**MARION TOWNSHIP PLANNING COMMISSION
AGENDA**

SUBJECT: Schroeder's Body Shop Amended Site Plan

Combined Amended and Final Site Plan Review for Marion Township Planning Commission

Petition Number	SPR 01-24 Schroeder
Applicant	Mathew Schroeder for Armstrong Property Holdings
Request	Combined revised and final site plan review for automobile repair garage (<i>including recreational vehicles</i>) and automobile/recreational vehicle sales
Location	50 Schroeder Park Eastern side of Pinckney/D-19, between Schroeder Park and Francis

PROJECT NO. 4710-01-00-025
HARON TOWNSHIP, LINCOLN COUNTY, WI
ADJUSTED SITE PLANS
SITE GRADING PLAN

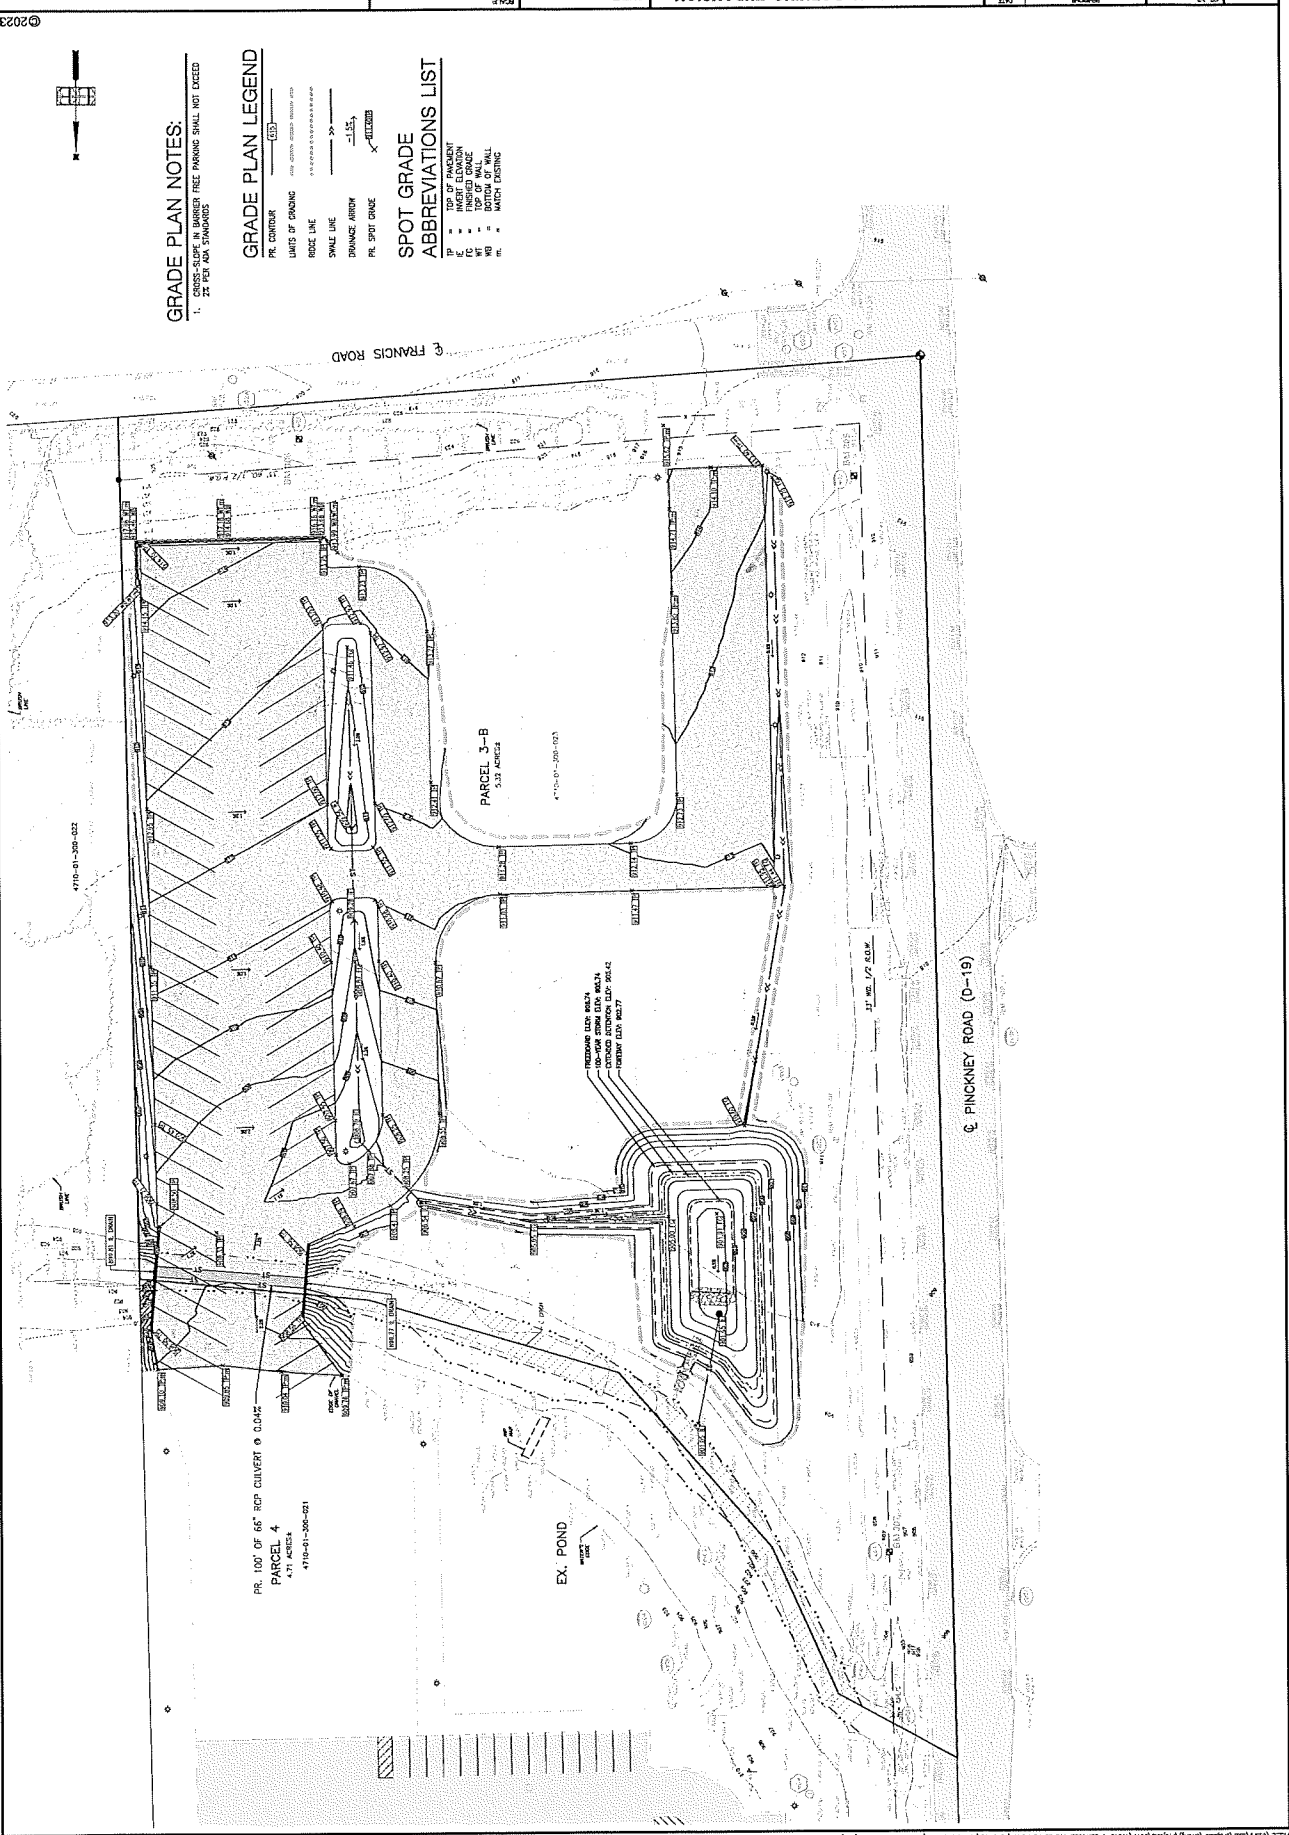
Topography	The site generally slopes downward to the center, between the 2 parcels. The southern property has significant slopes on the south along Francis and 2 mounds, with heights of 4 to 7 feet. The proposed parking area will be graded, and a retaining wall is proposed along the southern lot line.
Wetlands	The site plan shows wetlands and hydric soils in the central portion of the site.
Woodlands	There are no woodlands on the site, but there are a number of trees. The site plan identifies a single tree for removal, but more trees will be removed. The site plan does not identify the method or location of tree protection measures.
Soils	A majority of the area to be developed has either Miami loams or Owosso-Miami sandy loams, with are compatible with most

LANDSCAPE LEGEND

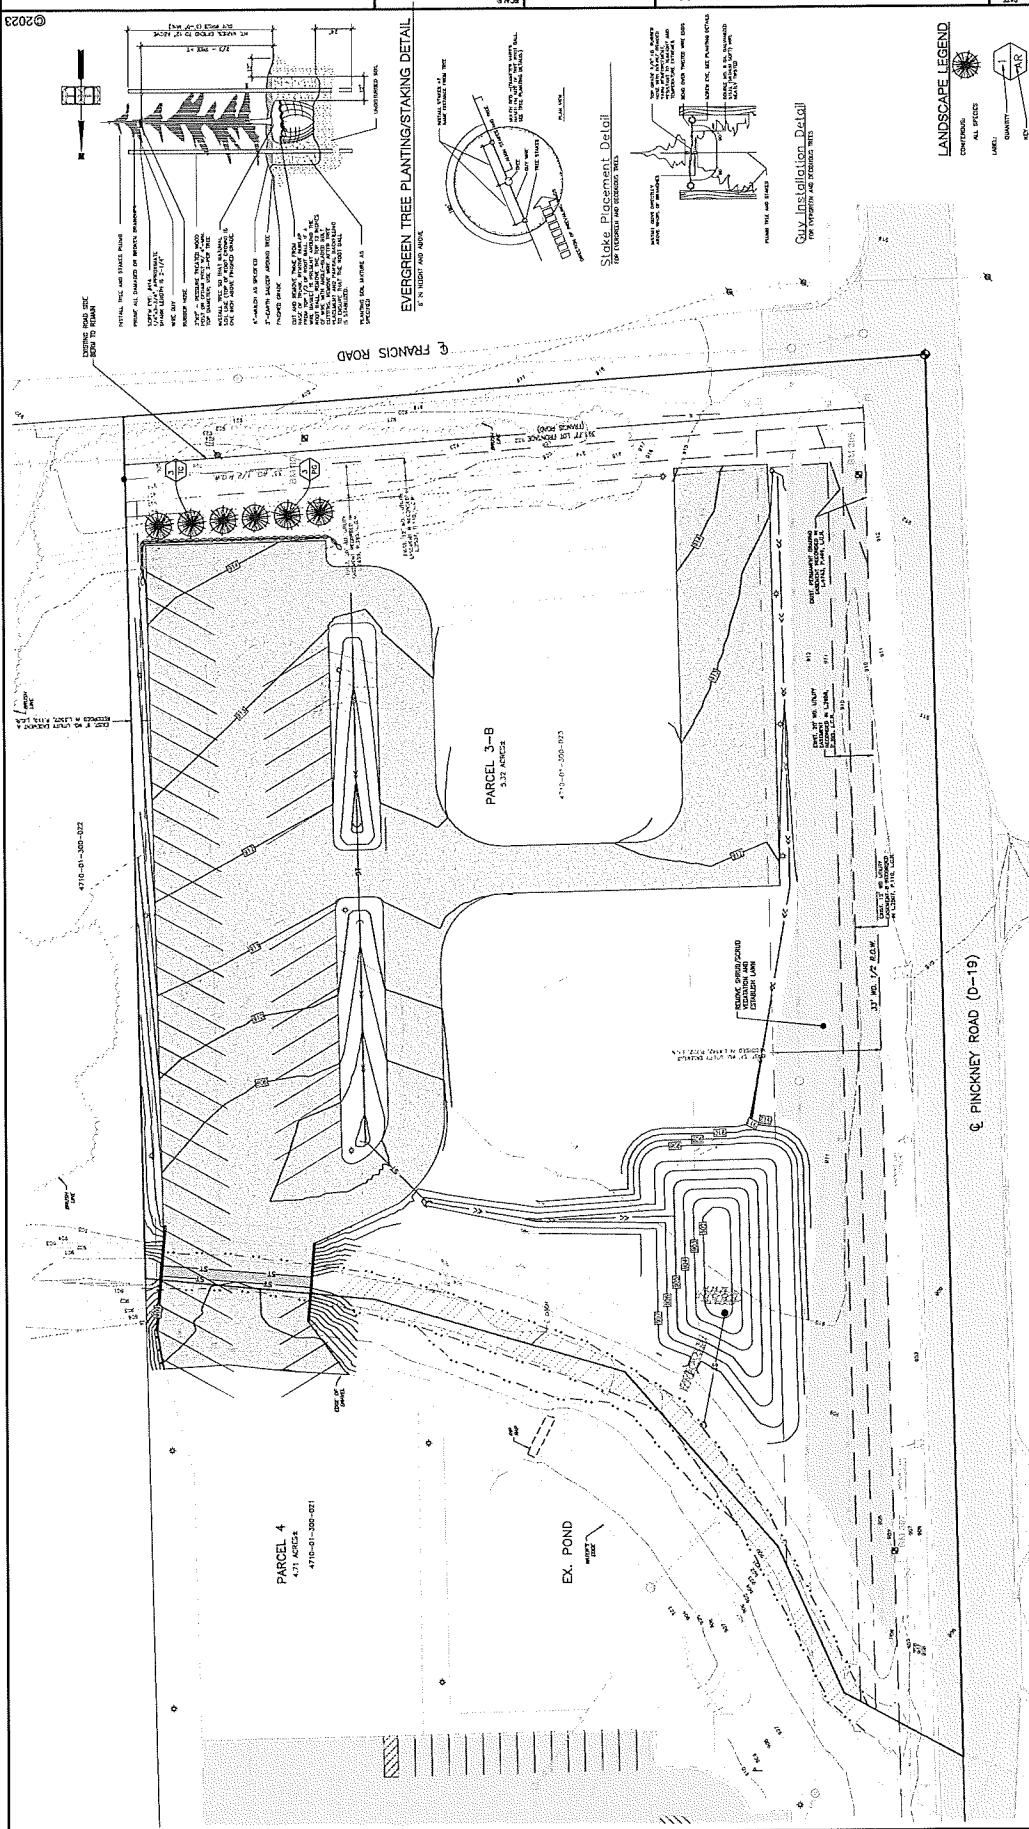
The landscape plan on Sheet C 8.0 proposes planting 6 evergreens, including 3 Eastern Hemlock and 3 Norway Spruce, along the western portion of the southern lot line along Francis. Landscaping is not proposed on the northern portion of the site, between the parking area and eastern lot line, between the parking/display area and Pinckney/D-19, or within the parking area.

Landscaping is required within or at the perimeter of parking lots, per §6.13(C) Parking Lot Landscaping. The landscape plan does not show any landscaping associated with any of the proposed parking areas. It also appears some parking landscaping shown on the original site plan was never installed or has been removed.

Items to be Addressed: 1) Trees species replaced with species less susceptible to disease or pest. 2) Mulch depth reduced to 3 to 4 inches. 3) Landscape plan revised to provide buffers, parking lot landscaping, and screening as noted above or calculations for required landscaping provided for consideration of waivers/modifications. 4) Landscaping on northern portion of the site installed/replaced consistent with that approved site plan.
